1 REDLINE REVISION 2/1/06
TEDD APPROVAL

MARYLAND DOT - STATE HIGHWAY ADMINISTRATION
*Office of Traffic & Safety*
TRAFFIC ENGINEERING DESIGN DIVISION

MD 190 AND LITTLE FALLS PARKWAY

| DRAWN BY: W J NIES | F.A.P. NO. | TS NO. 3180B | SHEET NO. 1 OF 3 |

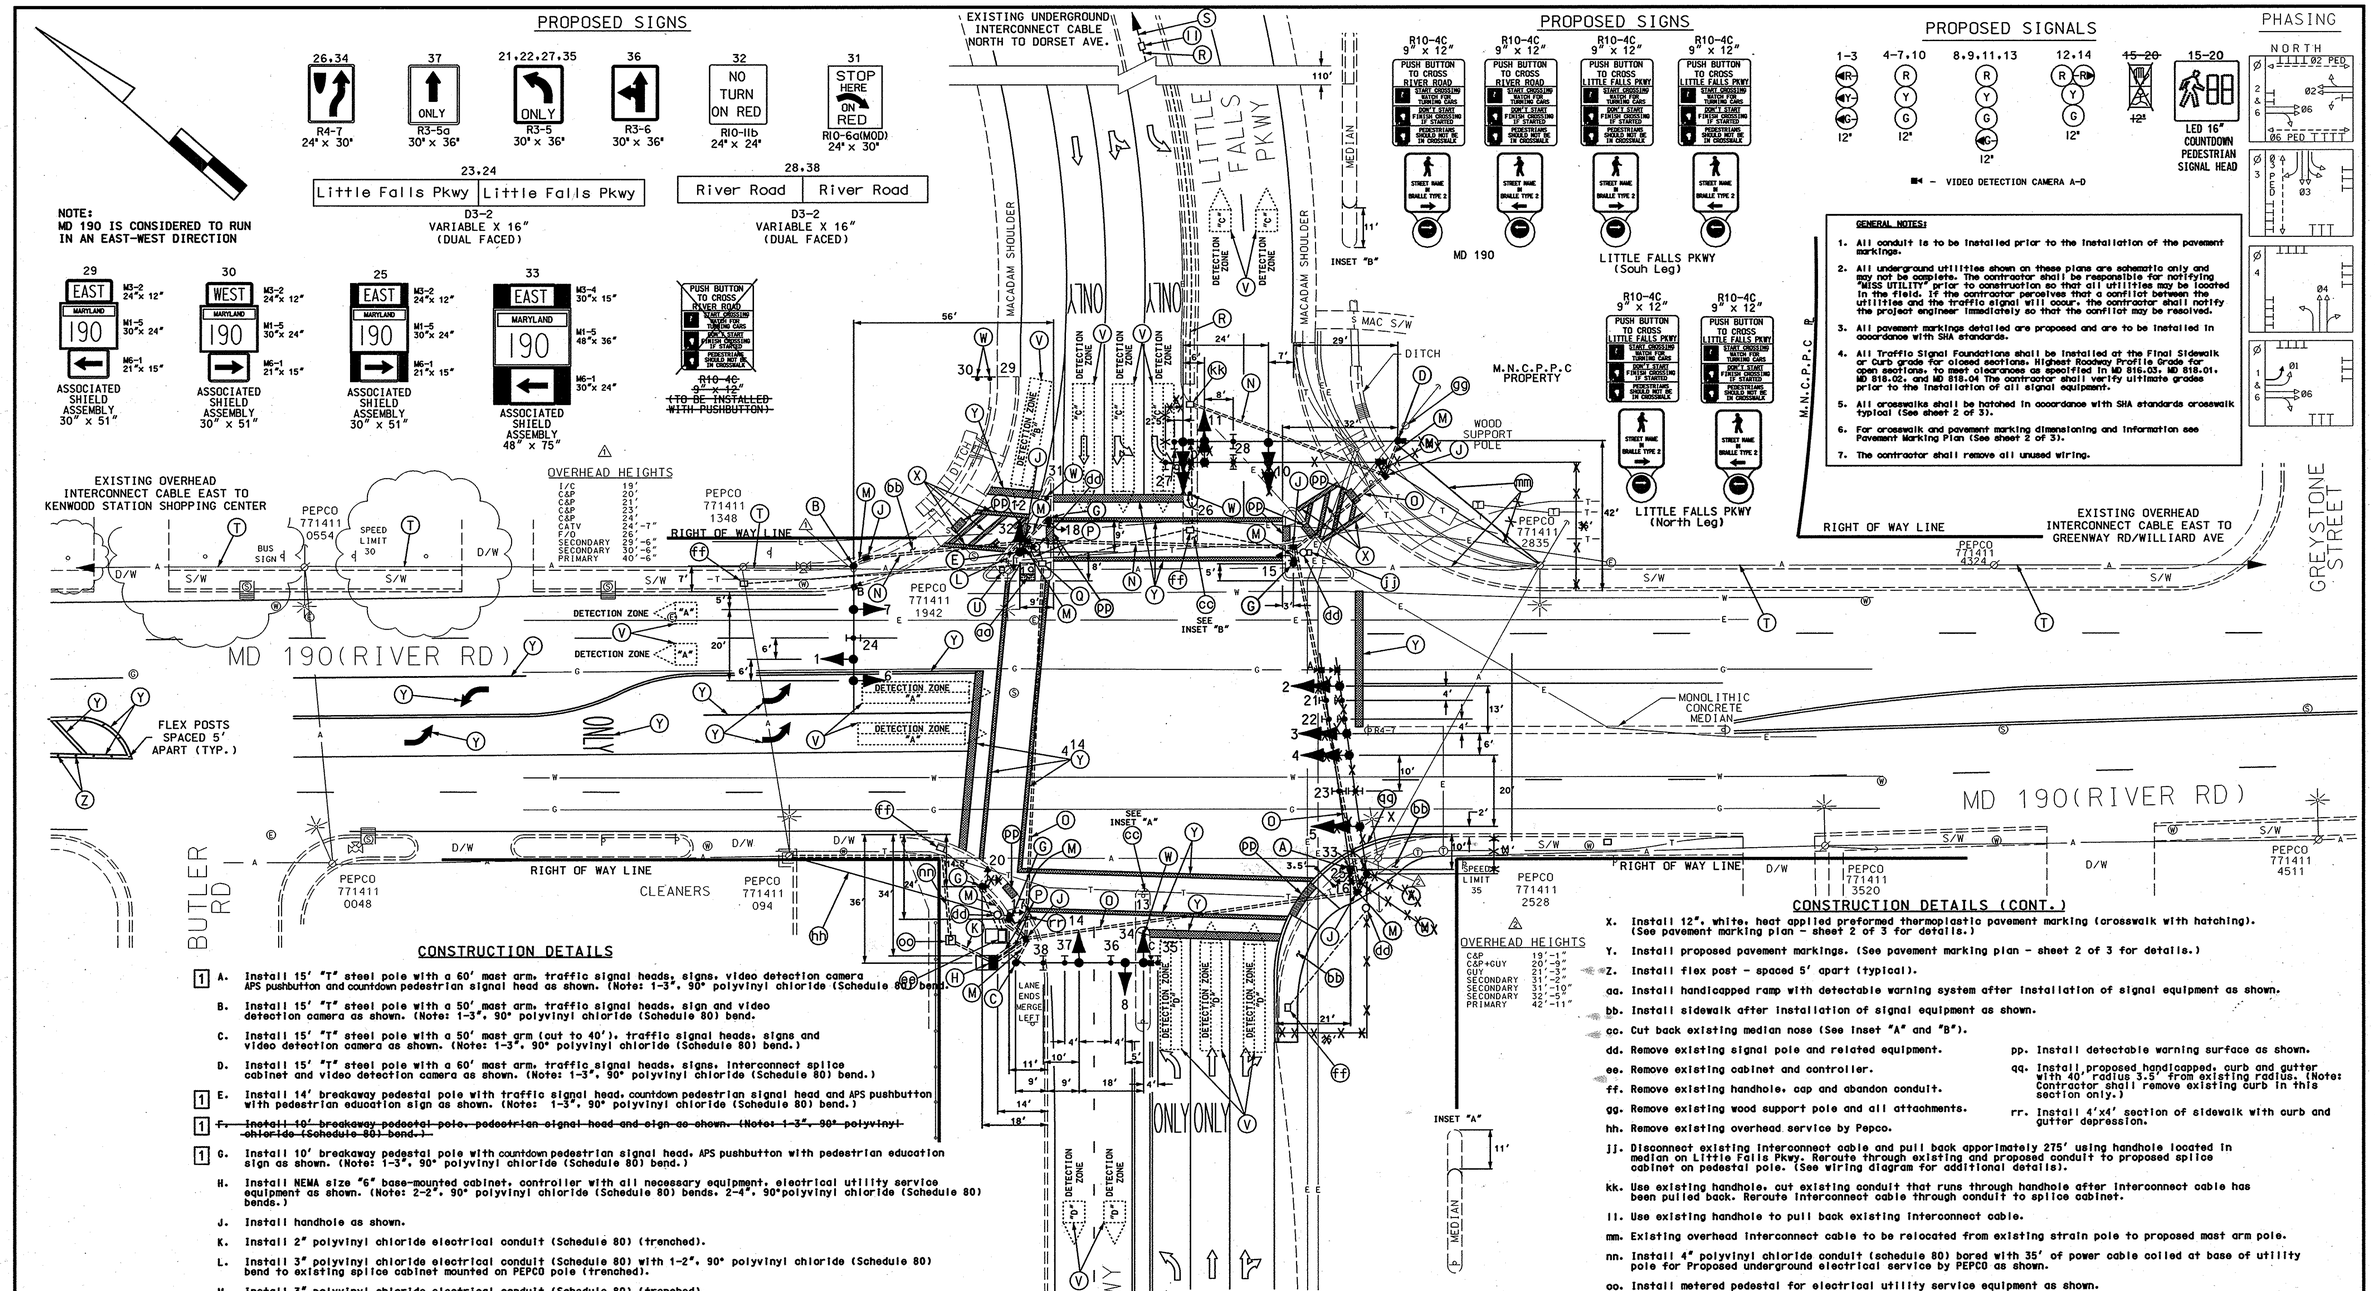
1 A. Install 15' "T" steel pole with a 60' mast arm, traffic signal heads, signs, video detection camera APS pushbutton and countdown pedestrian signal head as shown. (Note: 1-3", 90° polyvinyl chloride (Schedule 80) bend.)

1 E. Install 14' breakaway pedestal pole with traffic signal head, countdown pedestrian signal head and APS pushbutton with pedestrian education sign as shown. (Note: 1-3", 90° polyvinyl chloride (Schedule 80) bend.)

1 ~~F. Install 10' breakaway pedestal pole, pedestrian signal head and sign as shown. (Note: 1-3", 90° polyvinyl chloride (Schedule 80) bend.)~~

1 G. Install 10' breakaway pedestal pole with countdown pedestrian signal head, APS pushbutton with pedestrian education sign as shown. (Note: 1-3", 90° polyvinyl chloride (Schedule 80) bend.)
